NOTICE OF PUBLIC HEARING Minor Variance

APPLICATION	A-24:195	SUBJECT	160 Hughson Street South,
NO.:		PROPERTY:	Hamilton
ZONE:	"C5" Mixed Use Medium	ZONING BY-	Zoning By-law City of Hamilton 05-
	Density	LAW:	200

Re: Applicable Law Review – Zoning By-law Compliance
Zoning District: "C5" (Mixed Use Medium Density) Zone
Zoning By-law: Hamilton Zoning By-law No. 05-200
Address: 160 Hughson Street South, Hamilton

SITE PLAN

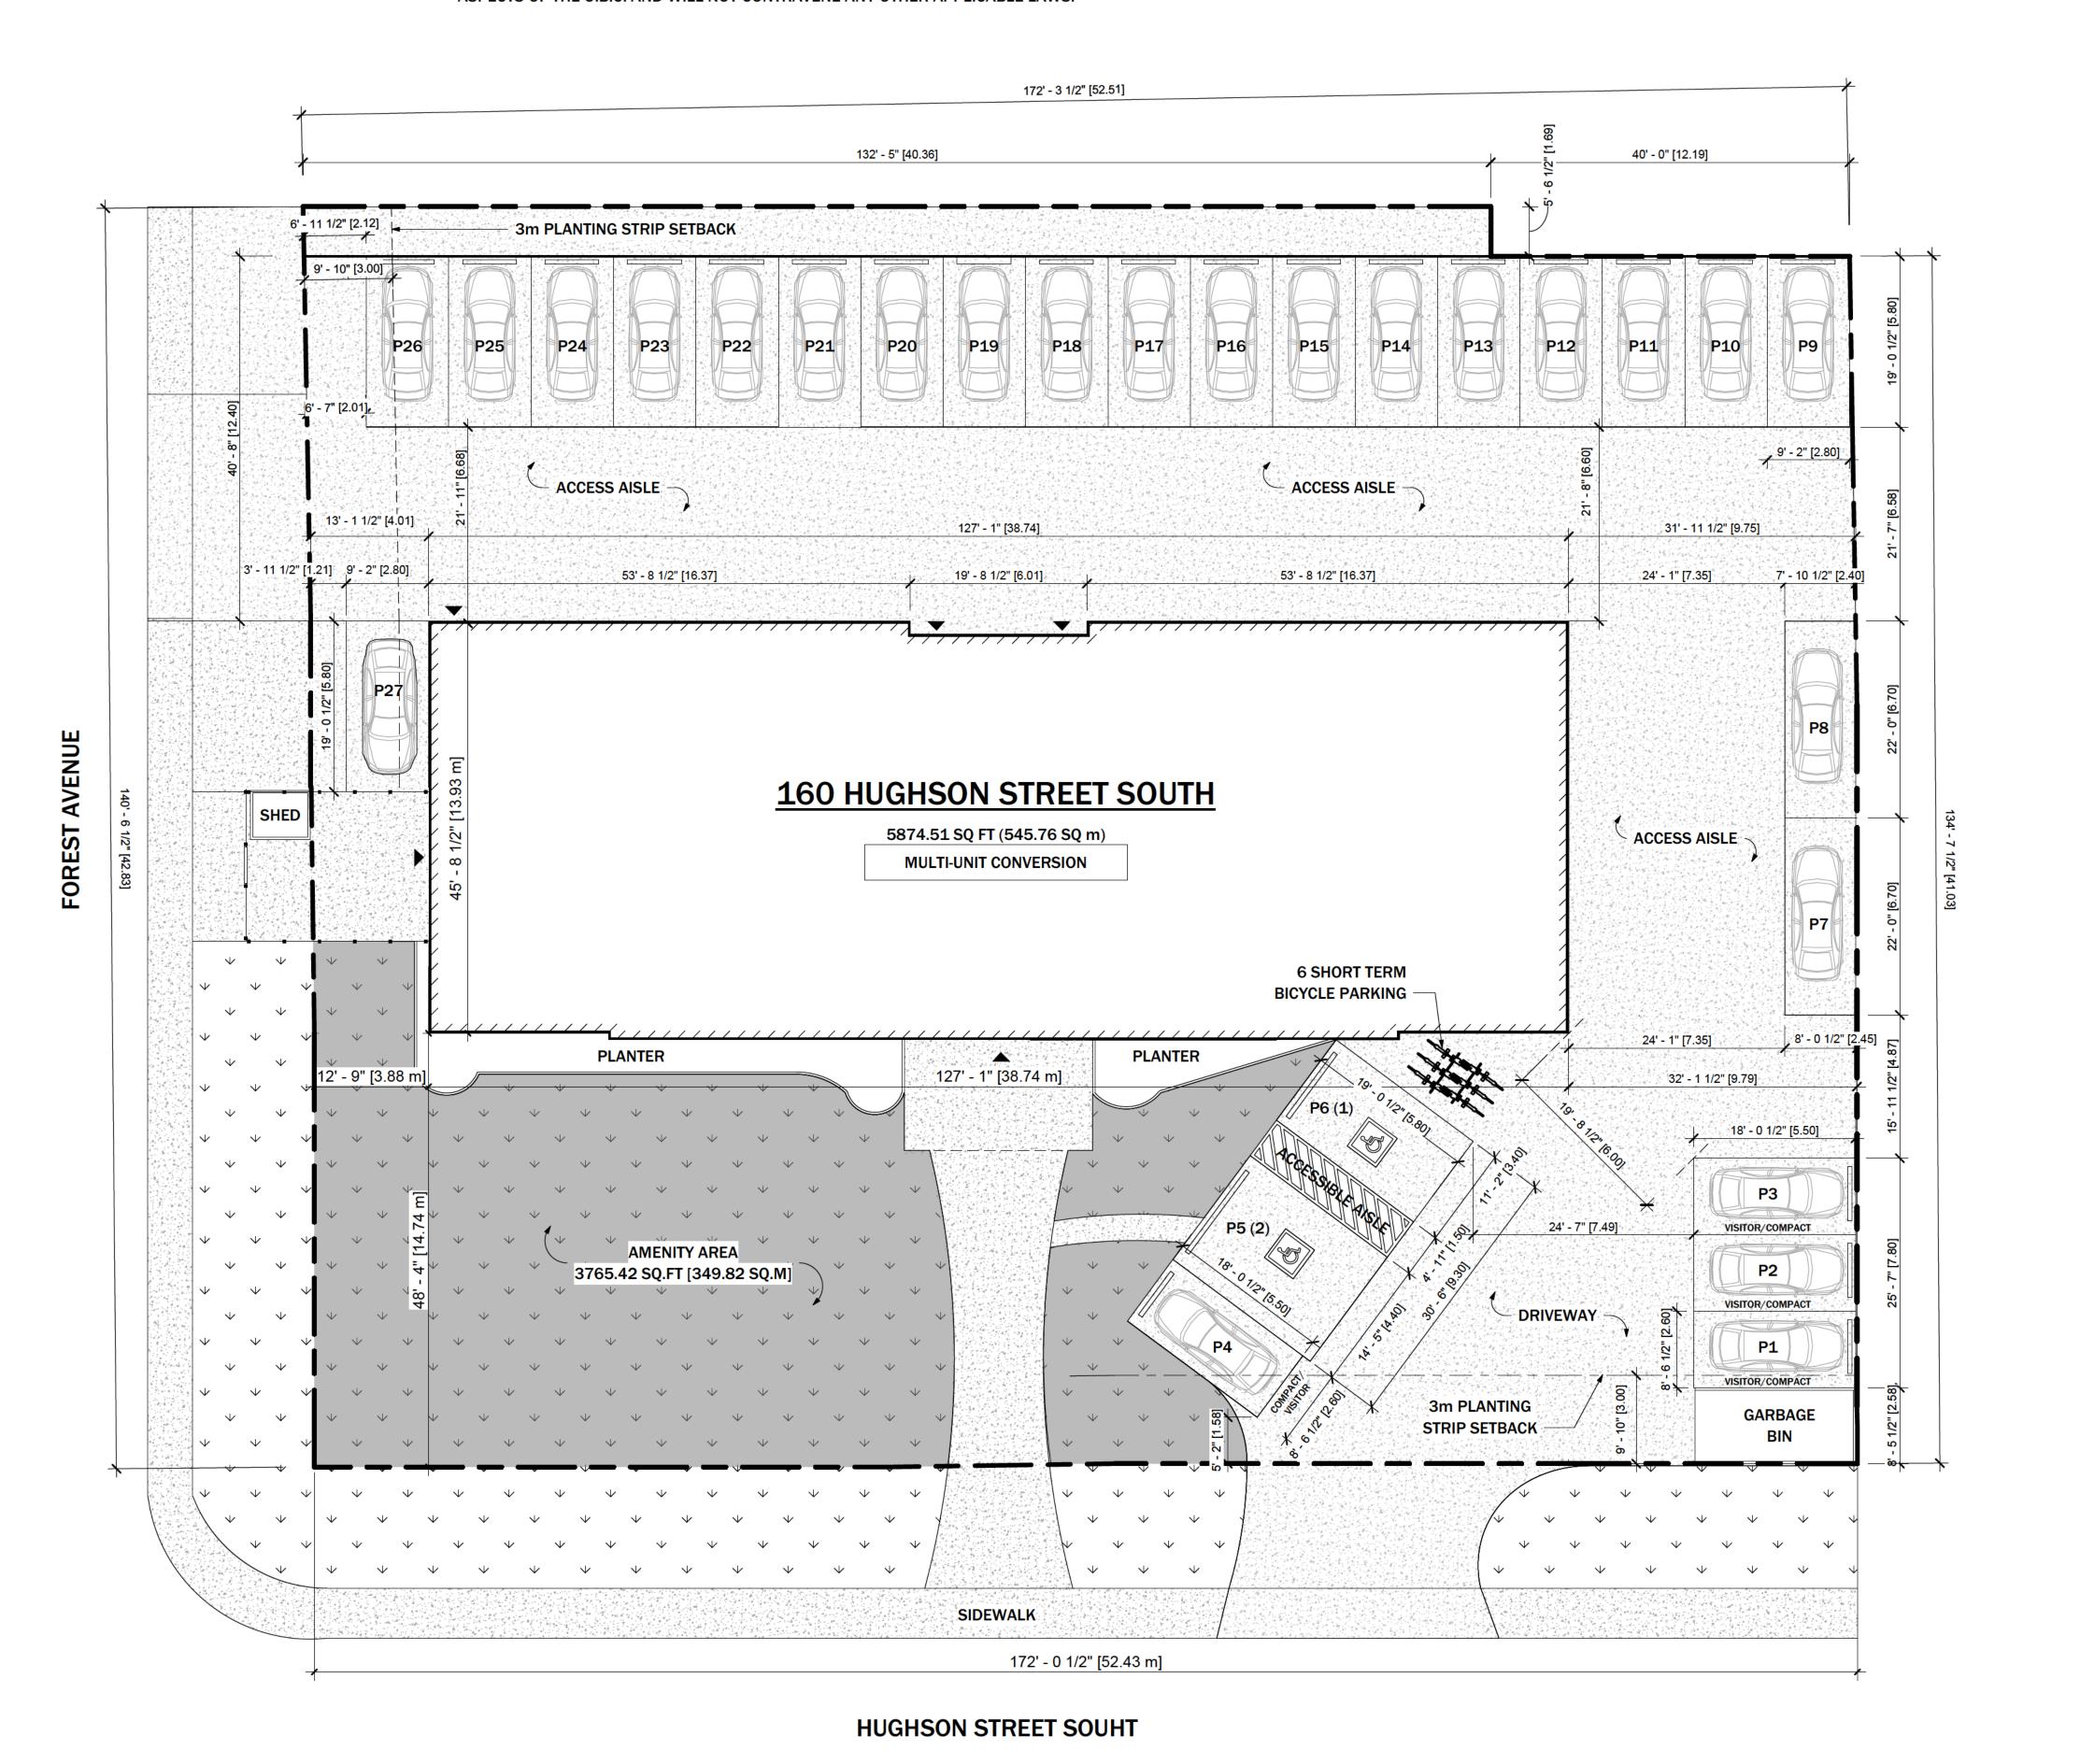
- 4. Building Division records indicate the last approved parking layout was in association with Building Permit No. BZ-20067 issued October 1, 1964. Parking was previously approved under former Hamilton Zoning By-law No. 6593, which required a total of forty-eight (48) parking spaces. Twelve (12) parking spaces were indicated to be provided in the existing garage area at the first-storey, and thirty-six (36) parking spaces were indicated to be provided in the surface level parking lot.

Based on the submitted Site Plan, it appears the proposed parking layout has been substantially altered from the original approved parking layout, and is further modified by converting the existing garage area to dwelling units resulting in a further reduction of parking on the lot. As the parking area no longer conforms to the approved parking layout or the current regulations which apply to the lands, a full zoning review has been conducted to bring the parking lot into conformity with the current regulations of Hamilton Zoning By-law No. 05-200.

By-law Requirement	Required	Provided	Conforms/
	located, pursuant to the agreement, shall continue to be so used only for such purposes until alternate parking spaces in conformity with the regulations of this By-law are provided. iv) Parking as provided for in Subsection iii) may be transferred to another lot in accordance with Subsection ii), provided that an agreement as required by Subsection iii) is registered on title of said other lot.		Non-conforming 1.58m
Parking Location from a Street Line and Planting Strips [Section 5.1 a) v) of Hamilton Zoning By-law 05-200]	v) Unless otherwise regulated in this By-law, parking spaces and aisles, giving direct access to abutting parking spaces, excluding driveways extending directly from the street, shall be subject to the following: a) Shall not be located within 3.0 metres of a street line, b) Shall provide a 3.0 metre wide planting strip being required and permanently maintained between the street line and the said parking spaces or aisle, except for that portion of a lot line abutting the Red Hill Valley Parkway and the Lincoln Alexander Parkway; and, c) Where a Planting Strip is provided, as per b) above, any architectural wall or feature within the Planting Strip shall be limited to a maximum height of 0.6	a) Parking spaces are indicated to be within 1.09 metres of the Hughson Street South streetline and within 1.51 metres of the Forest Avenue streetline b) A 3.0 metre planting strip has not been indicated between the parking lot and the Forest Avenue and Hughson Street South streetlines. c) An architectural wall or feature has not been indicated within the planting strip.	Non-conforming 1.21m

Location (Multiple Dwellings) [as per section 5.1(d) of Hamilton Zoning By-law 05-200]	metres. On a lot containing a multiple dwelling: i) With the exception of any visitor parking required by Section 5.6, required parking for multiple dwellings shall not be located between the façade and the front lot line or between the façade and flankage lot line. In no case	i) Parking is shown to be located between the façade and the front/ flankage lot lines. Parking spaces are indicated to be within 1.09 metres of the Hughson Street South	Non-conforming 1.58m

i) In addition to Subs minimum aisle width and provided in acco following requiremen	shall be designed rdance with the	A minimum aisle width of 6.0 metres has been indicated	Unable to Determine Compliance
	Parking Angle Degree	One-Way and Two-Way Aisle Width	through most of the parking lot; however, the minimum width	Compliant

0.	3.7m	between parking	
	15°	3.7m	spaces "P7" and "P3"	
	30°	3.7m	shall be indicated to	
	45°	4.5m	confirm compliance.	
	60°	5.5m		
	75°	6.0m		
	90°	6.0m		
Barrier Free Parking [as per section 5.5 of Hamilton Zoning By-law 05-200] *Shall not apply to Single Detached Dwellings,	Barrier free be designated as part of the i parking space accordance wi following requi	and provided required s in th the	Two (2) barrier free parking spaces are indicated.	Conforms
Semi-Detached Dwellings, Duplex Dwellings and	Required Parking Spaces	Designated Barrier Free Parking Spaces		
Street Townhouses abutting a public street.	1 – 49 Spaces	Minimum 1 space;

Multiple Dwelling Front and Flankage Yard Parking Restriction Section 5.3.1(c)	In addition to Section 5.3.1 a), on a lot containing a Multiple Dwelling: i) With the exception of any visitor parking required by Section 5.7.1, required parking for Multiple Dwellings shall not be located between the façade and the front lot line or between the façade and flankage lot line. In no case shall any parking be located within the required front yard or required flankage yard or within 3.0 metres of a street line. ii) Visitor parking may be permitted between the façade and a street provided that no more than 50% of the front or flankage yard shall be used for visitor parking and access to such parking. NOTE: Five (5) visitor parking spaces required	i) Parking is shown to be located between the façade and the front/flankage lot lines. Parking spaces are indicated to be within 1.09 metres of the Hughson Street South streetline and within 1.51 metres of the Forest Avenue streetline. ii) In addition to the five (5) required visitor parking spaces ("P1" – "P3" and "P4" and "P5"), two (2) barrier free parking spaces are indicated between the facade and Hughson Street South. One (1) standard parking space is indicated ("P28") is indicated between	Non-conforming

By-law Requirement	Required	Provided	Conforms/ Non-conforming
Minimum Bicycle Parking Rate Schedule Section 5.7.5(a) NOTE: The subject lot is identified on Schedule "A" to Appendix "D" as a Parking Rate Area 1	Multiple Dwelling where the total number of units exceeds 4: Short-term Bicycle Parking: (a) In Parking Rate Area (PRA) 1 and PRA 2, 0.1 per unit. CALCULATON: 70 x 0.1 = 7 short-term bicycle parking spaces are required to be provided. (b) In all other areas, 0.05 per unit. Long-term Bicycle Parking: (a) In Parking Rate Area (PRA) 1 and PRA 2, 0.7 per unit. CALCULATON: 70 x 0.7 = 49 long-term bicycle parking spaces are required to be provided. (b) In all other areas, 0.5 per unit.	Six (6) short-term bicycle parking spaces are indicated at grade. No long-term bicycle parking spaces have been indicated.	Non-conforming
